# CITY OF MERCER ISLAND

## APPEAL

Appeal to a permit to correct un-permitted structures in the back yard of 8636 House.

Project number is #CAO24-036 Permit Type III; and #2401-034

TOPOGRAPHIC SURVEY  
 KAN CUI & LIU YAN  
 8536 N MERCER WAY  
 MERCER ISLAND, WA 98040

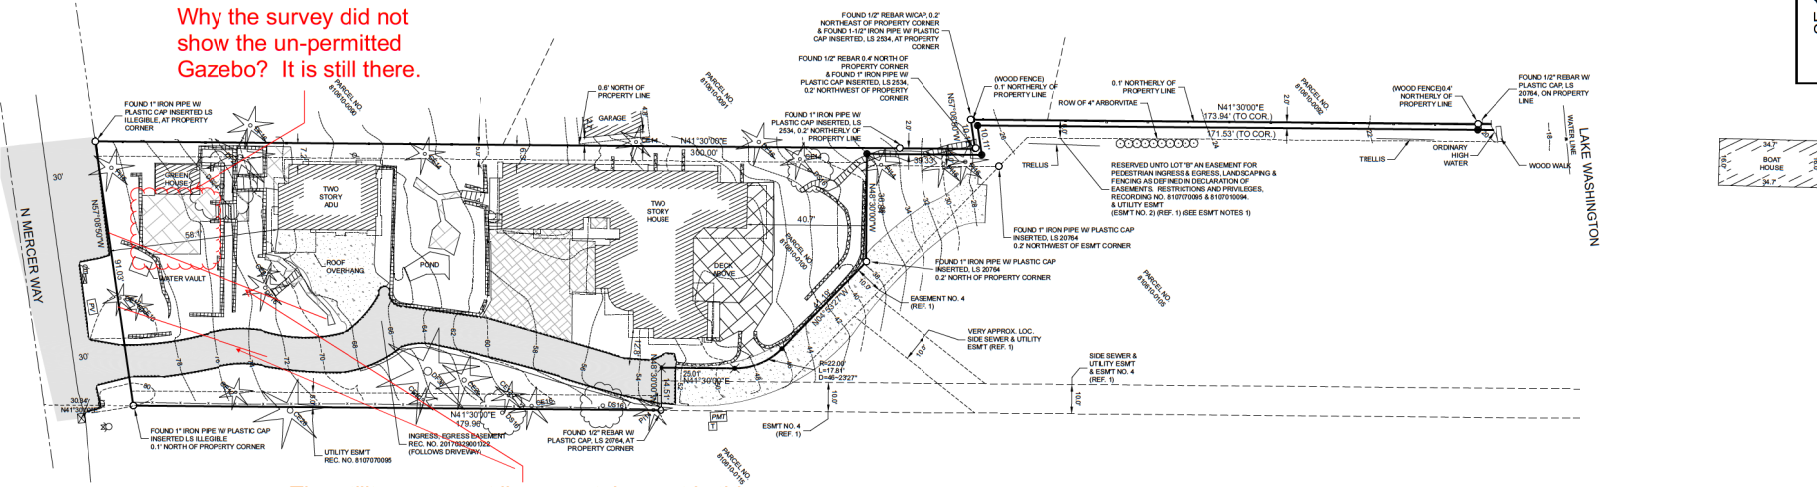
Why the survey did not show the un-permitted Gazebo? It is still there.

The utility easement lines are taken out in this version dated 9-11-2025. Need to add back, shown in 4/4/2023 version of survey.

5 BUILDING SECTION  
SCALE: 1/4" = 1'-0"

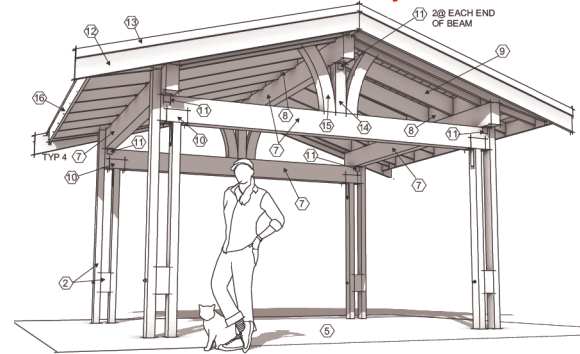
The project shall also include relocate the Glass Greenhouse by 2 ft - 3inch. relocate the retaining wall intruding the side set back and the utility easment.

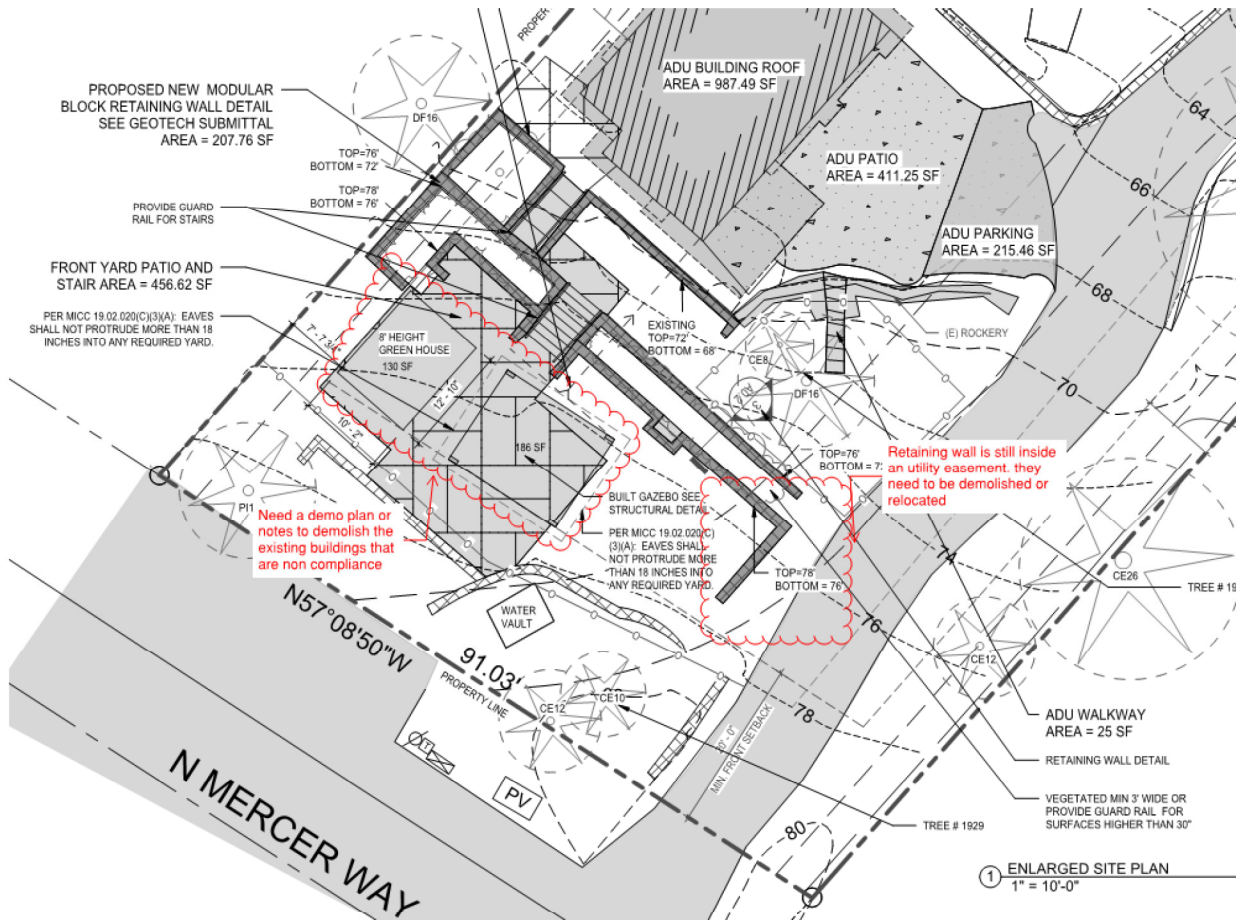
3-24-2025 my review comments - Site Plan – show both greenhouse and Gazebo intrude into the 20 ft property setback. See red circled above. However, in the later versions the Green house size seem shrunk and show not intruding anymore? Why?

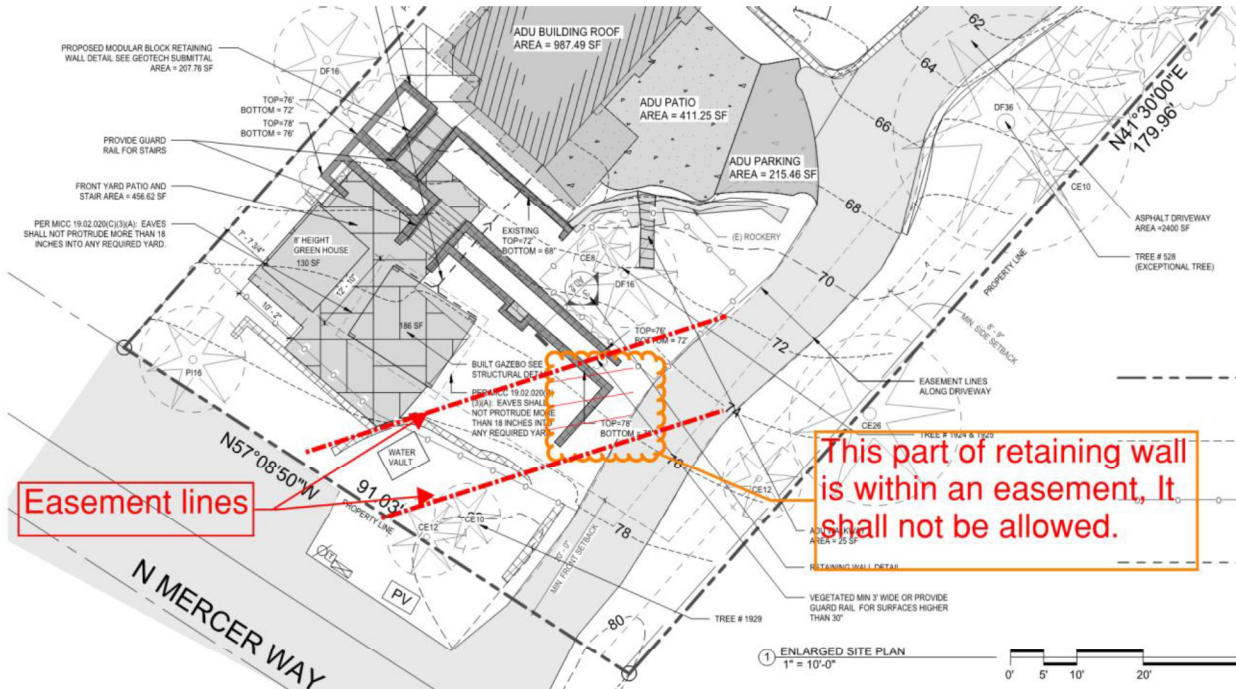
8-4-2025 Review comments - Site Plan. From the above plan, the Greenhouse seems stayed right outside of the 20 ft set back. It conflicts with the plan I received for my 3/24/2025 review comments. At that time, the permit plan shows the Greenhouse intrudes into 20 ft setback by 2'-3.5". (see the first page).

11-1-2025 Public appeal 8636 plan – they have the same problems as shown in the 8-4-2025 review comments (page 2 above);

And new issue - the dot lines showing the old driveway was deleted.

1. The old easement shown by dots lines should be added back to the plan.
2. The retaining walls still intrude into the easement. They should be removed.
